MCTC-41 Series

Appearance Change Notification

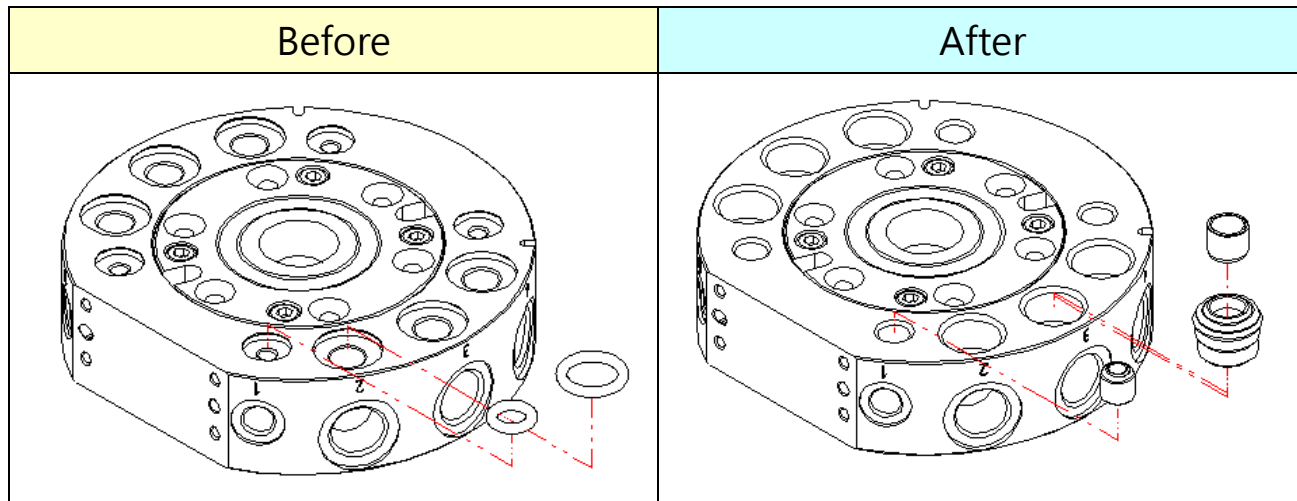
1. Model series
MCTC-41
2. Design change reason
Optimized seal design
3. Change descriptions

4. Effective date
It will not affect usage, and will replace sequentially.
5. If there is any question, please contact our sales department.
